# POLICY REPORT DEVELOPMENT AND BUILDING

TO:	Vancouver City Council
FROM:	Director of Planning
SUBJECT:	CD-1 Rezoning: 428 Terminal Avenue

### 428 Terminal Avenue PROPOSED CONDITIONS OF APPROVAL

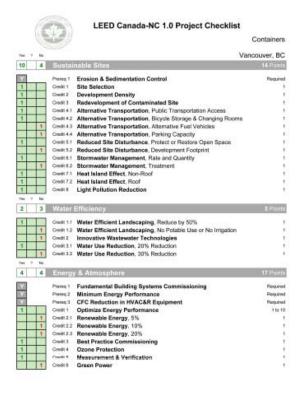
- 1) Public corridors must be a minimum of 9 meters apart for phase 1.
- 2) Office no. 2 on phase 1, L1 floor requires two exits.
- 3) Universal Toilet Room is required for both phases.
- 4) Exit stair number two requires fire separations with ratings for phase L1 floor.

5) This building in phase 2 is a potential high-rise building meeting Subsection 3.2.6.6) Spatial calculation is required for this project.

Figure 2: Context Site Plan at Grade

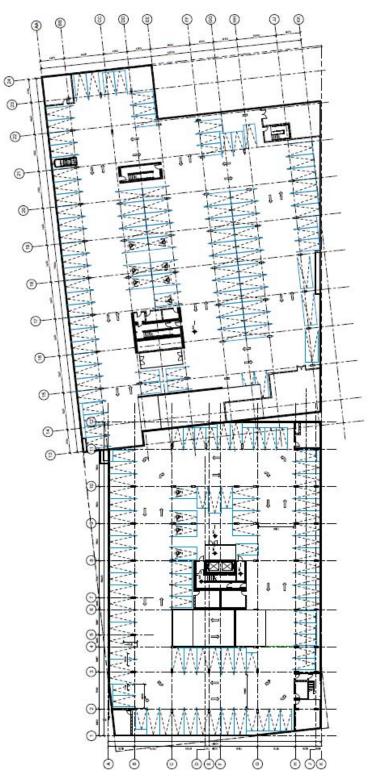
1. clarification on the drawings, removing pedestrian ramp structure;

2. design development to the building massing, breaking up the long facades through greater articulation and expression of building parts;

- 5. design development to enhance the public and semi-public realm of the centre mews and street edges for pedestrian uses in the following manner:
  - a. provide weather protection along the Terminal Avenue frontage within the 3 m setback;

b. Remove or relocate the open parking ramp;

- c. minimize the visual impact of exposed mechanical vents located in the centre mews, either relocating away from the central court area or transforming them into an attractive feature that is integrated with the landscaping;
- d. confirmation on the drawings that the parking ramp access and all loading bays are gated;

Note to Applicant: The pedestrian ramp is not part of this application. Dimension on the site plan the easement required for a future pedestrian ramp.

Note to Applicant: The I-3 District Guidelines for the False Creek Flats suggest building depths or widths that exceed 30.5 m (100 ft.) should be physically separated into a series of buildings, or be designed to appear so. The aim is to create identity, rhythm and variety. *Reference: I-3 District Guidelines False Creek Flats, Section 4.16 building depth (and width).*

Note to Applicant: The canopy should be a minimum depth of 5 feet, clear glazed and located below the crown of adjacent trees. Altering of proposed tree spacing may be required. Provide a hard surface for a pedestrian path, modifying ground landscaping as required.

Note to Applicant: If combining the ramps provide a knock out panel between parking structures. *Reference: I-3 District Guidelines False Creek Flats, Section 2.9 Off-Street Parking and Loading.*

Figure 3: Elevations

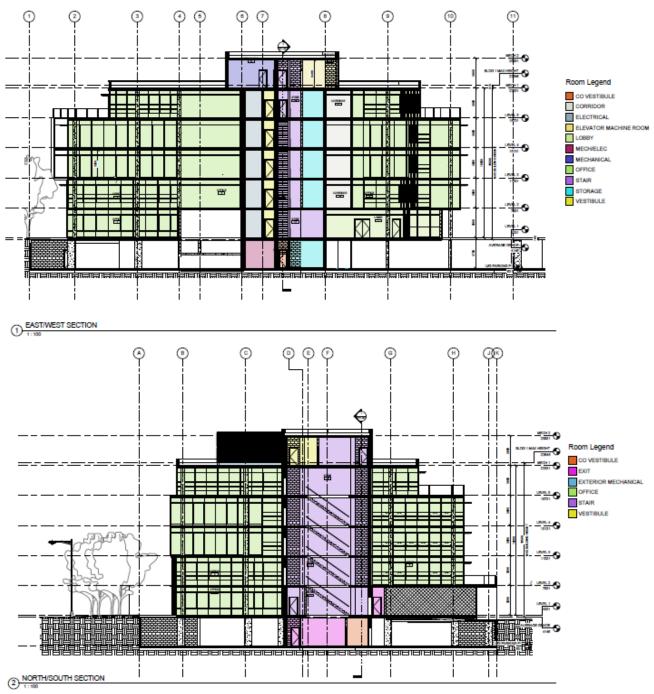
- 3. design development to improve the architectural expression in the following manner:
  - a. more material variety and colour; and

b. consider better quality glazing system, such as frameless, indicating on the drawings and providing sample documentation;

10. consideration to improve the passive solar strategy on the west elevation;

Note to Applicant: Exterior building design should reflect the industrial character of the precinct by utilizing high-quality, durable materials. *Reference: I-3 District Guidelines False Creek Flats, Section 5.5 Exterior Walls and Finishing.*

Note to Applicant: The quality of the glazing system should be of a comparable standard to the previous Development Permit application. The use of mirrored or highly reflective glass is discouraged to allow views into building activities.

Note to Applicant: Adding vertical fins to the west elevation will enhance the solar performance.
